Shatin to Central Link

Verification & Assurance of As-constructed Conditions

of the Hung Hom Station Extension

Engineering Expert Report

Figure 3. Dimensions of Seisplice Type A couplers

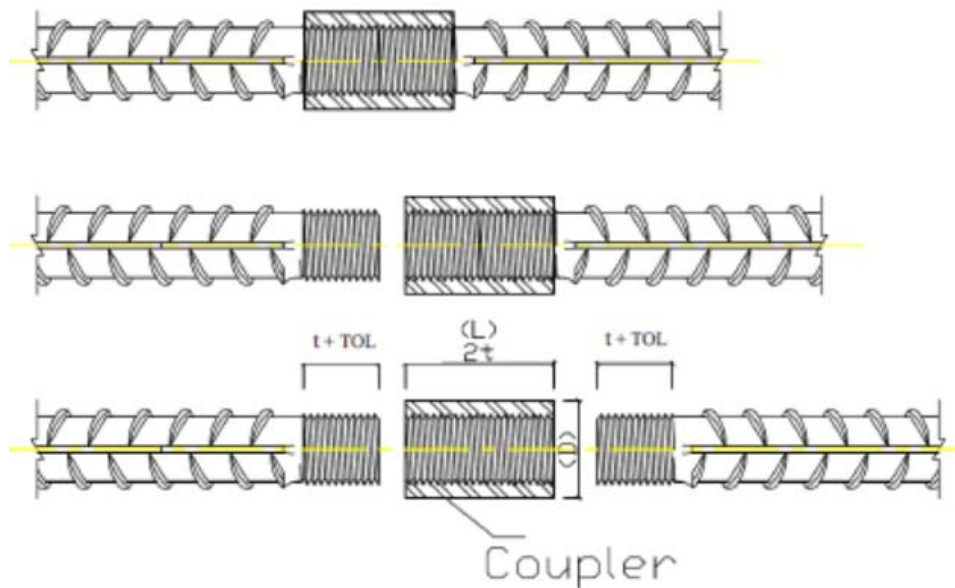
95. The threaded section of a 40-mm diameter Type A reinforcement steel bar is 44 mm. The number of full threads is between ten (10) and eleven (11). With a tolerance of 4 mm, the total number of full threads is between eleven (11) and twelve (12).
96. The acceptance criterion recommended by the manufacturer is shown in Figure 4. It can be deduced from Figure 4 that the minimum embedment length is 40 mm and the minimum number of full threads engaged should be ten (10).

Figure 5. Types of EWL Slab / D-Wall (East) connections

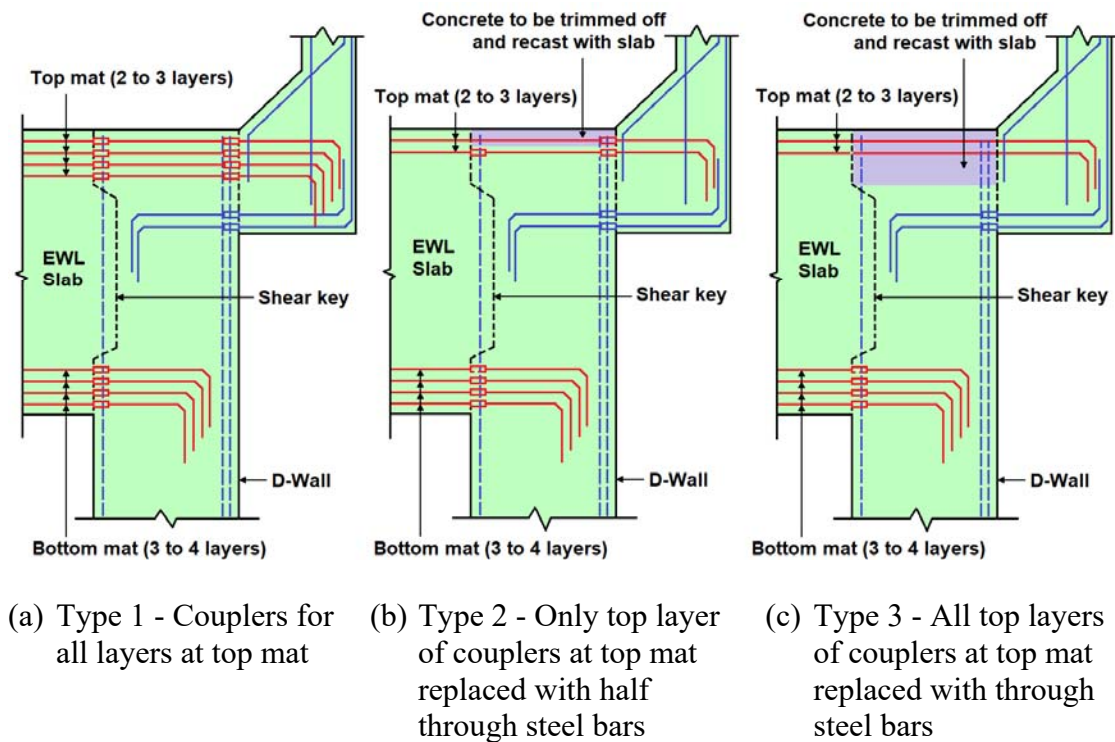
122. I understand that Type 1 connection was the original design by Atkins. Both Type 2 and Type 3 connections are modifications of the original design by Leighton to suit its construction procedure. However, I have no information whether the modifications have been accepted by the BA of the HKSARG.

124. The coupler observed was probably installed to suit site conditions for the construction of the slab outside D-Wall (East) to the east and not part of the modified design. I have no information whether such a change in reinforcement details has been

reported to Atkins, the MTRCL or the BA of the HKSARG. Provided the requirement of embedment length of the reinforcement steel bar in the coupler satisfies the installation requirements of the manufacturer, the structural integrity of the rebar connection should not be a technical problem. However, such a change in reinforcement details from the design should be documented and reported to relevant authorities.

Figure 6. Proposed location for further opening-up

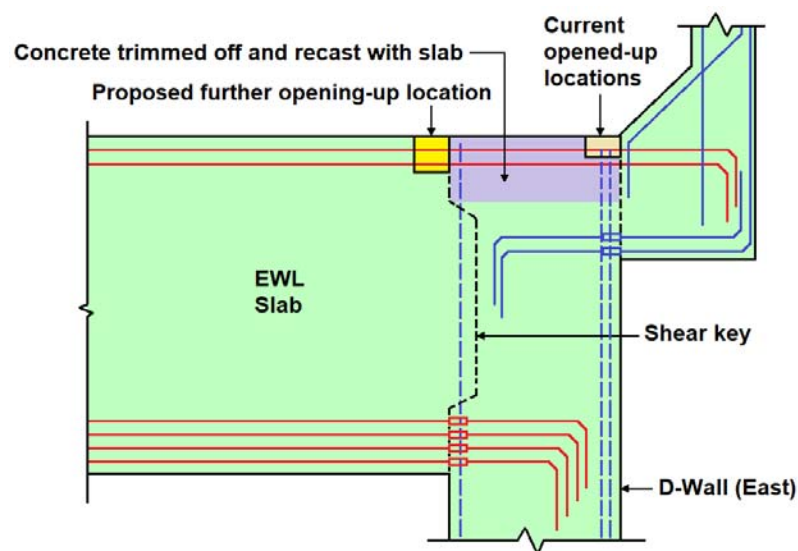
125. However, the two (2) opened-up locations as shown in Figure 6 are within D-Wall (East) but close to the eastern edge of D-Wall (East). The size of the opened-up is approximately 250 mm by 250 mm on plan. The depth of the opened-up could barely expose the top layer of reinforcement steel bars. Therefore, only some of the reinforcement connections on the eastern edge of D-Wall (East) could be inspected. The actual reinforcement connection details between the EWL Slab and D-Wall (East) at the western edge were practically not inspected at all, not to mention the confirmation of replacement of coupler-connected reinforcement steel bars by through steel bars into the EWL Slab. Further opening-up is thus required to confirm all top layer(s) of couplers of the top mat were replaced with through steel bars. In particular, some opened-up locations should be placed on the top surface of EWL Slab west of D-Wall (East) as shown in Figure 6 to confirm whether Type 2 or Type 3 connections were actually constructed.

126. The confirmation that the top reinforcement steel bars are through bars and not laps between bars at the proposed location is of paramount importance to the structural adequacy of the EWL Slab. If there are laps between reinforcement steel bars, they probably cannot comply with the requirements of CoP 2013 on laps as elaborated below.

129. If it is absolutely necessary to place laps between reinforcement steel bars at the suggested location of open-up, which I disagree, the laps between steel bars should be staggered and the arrangement of lapped bars should comply with figure 8.4 of CoP 2013. Therefore, the width of the open-up should at least cover two sets of reinforcement steel bars to inspect whether the laps between steel bars are staggered, if there are any lapped bars.
